Project	IEEE 802.16 Broadband Wireless Access Working Group < http://ieee802.org/16 >
Title	Correction of RS Preamble Configuration Request (RS_Config-REQ) Message
Date Submitted	2007-05-03
Source(s)	<p>Changqin Huo, Dorin Viorel, Aram Sukiashyan, Chad Gilbertson, Jagan Seshadri Fujitsu Microelectronics Canada Inc.</p> <p>Mike Hart Fujitsu Laboratories of Europe Ltd.</p> <p>Peiyong Zhu, Israfil Bahceci Nortel 3500 Carling Avenue Ottawa, Ontario K2H 8E9</p> <p>Mary Chion, Kim Olszewski ZTE USA</p> <p>Jeffrey Z. Tao, Koon Hoo Teo, Jinyun Zhang Mitsubishi Electric Research Lab</p> <p>Toshiyuki Kuze Mitsubishi Electric Corp</p> <p>Junhong Hui, D.H. Ahn ETRI 161, Gajeong-Dong, Yuseong-Gu, Daejeon, 305-350, Korea</p>
	<p>dviorel@fmci.fujitsu.com; Voice: +1 403-207-6311</p> <p>mike.hart@uk.fujitsu.com; +44 (0) 20 8606 4539</p> <p>pyzhu@nortel.com Voice: +1 613 763-1315</p> <p>mchion@zteusa.com</p> <p>tao@merl.com, Voice : +1 617 621 7557</p> <p>Kuze.Toshiyuki@ah.MitsubishiElectric.co.jp, Voice : +81 467 412885</p> <p>junhonghui@etri.re.kr</p>

Correction of RS Preamble Configuration Request (RS_Config-REQ) Message

Figure 1 Cell coverage area augmentation due to RF power amplifier's input backoff factor

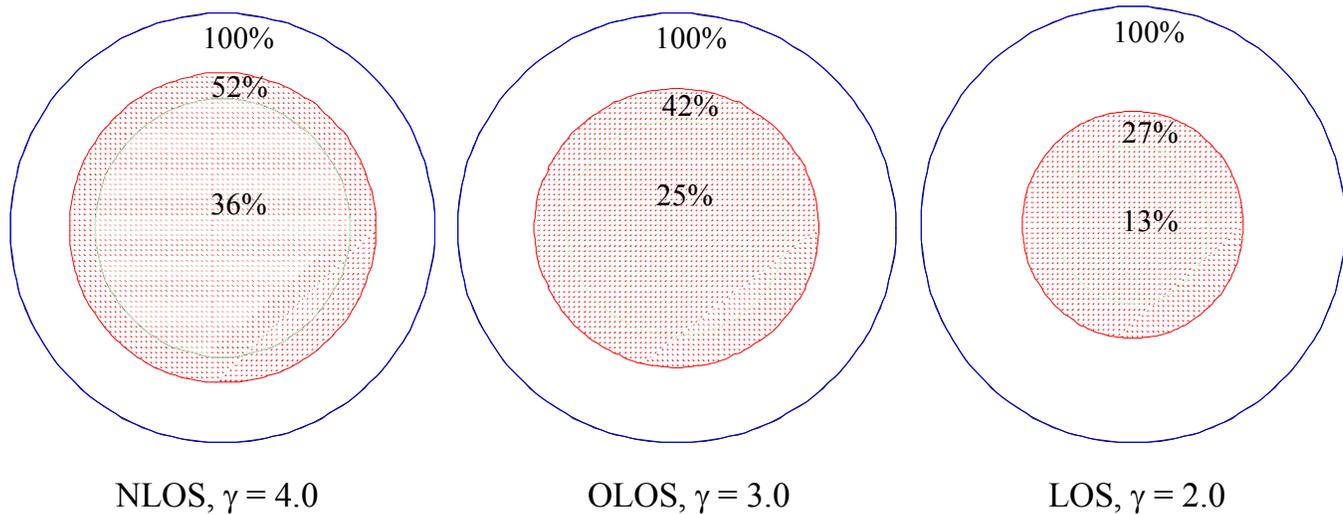
Figure 1 depicts the RF coverage shrinkage effect due to the power backoff for N_{Preamble} of 2 and 3 when the path loss exponent γ is 4 (NLOS), 3 (OLOS) and 2 (LOS), respectively. It could be noticed that the coverage area approximately shrinks by 58% and 75% for N_{Preamble} of 2 and 3, respectively, at γ of 3 (a typical value for obstructed LOS wireless environment), for 1k FFT case. When γ equals 2 (LOS), the RF coverage approximately shrinks by 63% and 87% for N_{Preamble} of 2 and 3, respectively.

Considering Fig. 1, the following assumptions have been made:

- The outer circle (annotated with 100%) corresponds to the service area covered by a one preamble related transmitting RF power
- The first inner circle (pattern filled) represents the 2 preamble coverage area, referenced to the same initial transmitted (one preamble) RF power

- The inner circle represents the 3 preamble coverage area, referenced to the same initial transmitted (one preamble) RF power
- The 1k FFT case is analyzed, considering the input back off factor degradation presented in Table 1, for 2 and 3 preambles referenced to the one preamble transmission situation

The multiple preamble transmission at a single RS shall not be supported. In other words, N_Preamble shall be 0 (transparent mode) or 1 (non-transparent mode).

Figure 3 Two simultaneous preambles transmission impact over the spectrum of a RF PA (see assumptions) against a WIMAX 2.5 GHz spectrum mask

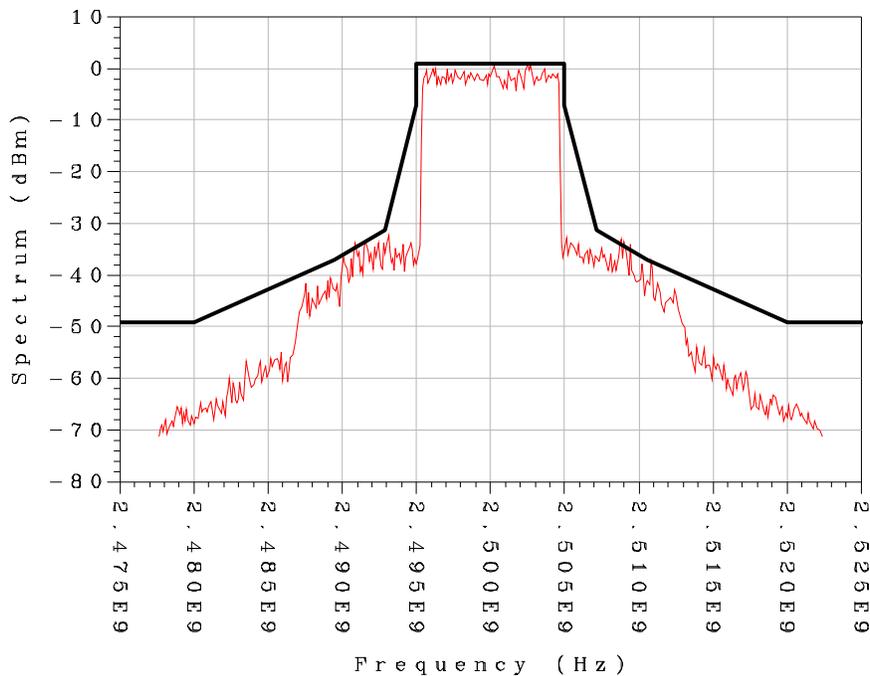
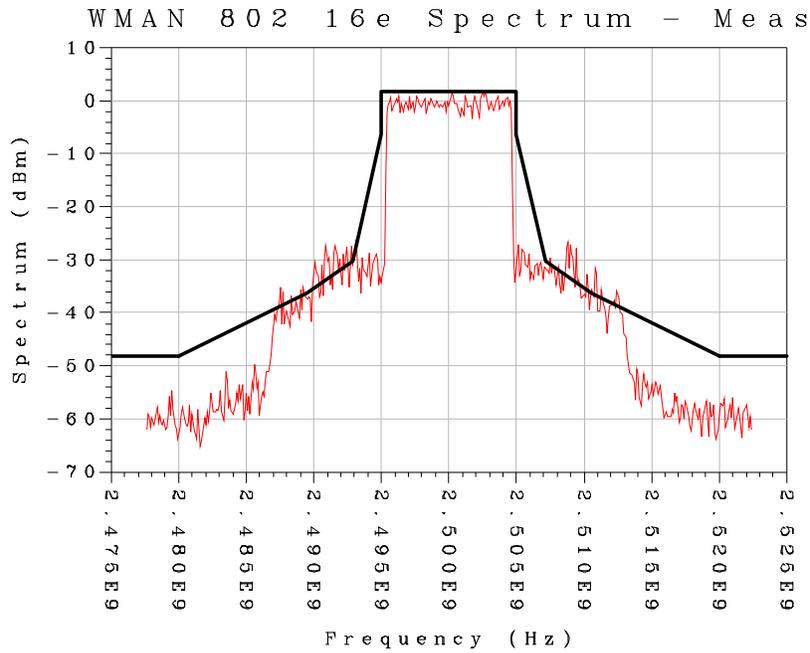
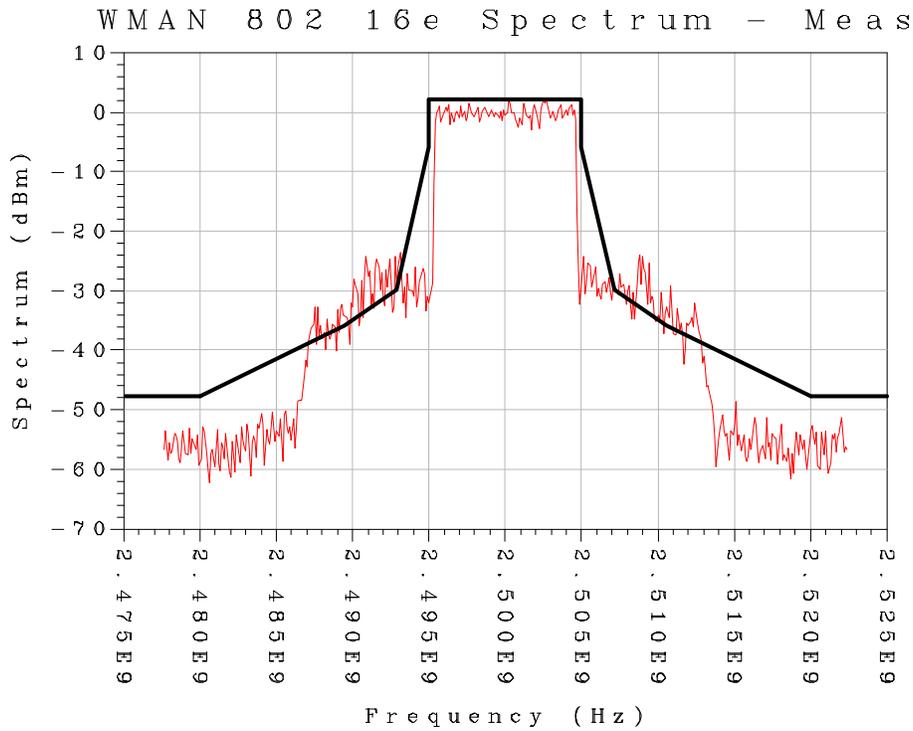
In order to simulate the spectral mask impact of a multiple preamble transmissions, the following assumptions have been made concerning typical RF Power Amplifier (PA) with the following characteristics: P1=34 dBm, TOI (IP3)= 45 dBm, Gain = 35.0 dBm, BW=10 MHz. The RF PA has been modulated with an 802.16e frame structure based on a 1k FFT, DL PUSC allocation.

The purpose of the exercise was to simulate the compliance level of the related spectrum against a WIMAX 2.5 GHz spectrum mask (pre-approved WIMAX spectrum mask for 3A profile, for the May 2007 WIMAX TWG FtF meeting).

Concluding the simulations presented in Fig.2, 3 and 4, it is apparent that a multiple preamble 802.16j frame structure would require a different WIMAX spectrum mask than the actually pre-approved one. Therefore the 802.16j RSs would require a different spectral mask than the (expected to be) certified 802.16e BS spectral mask.
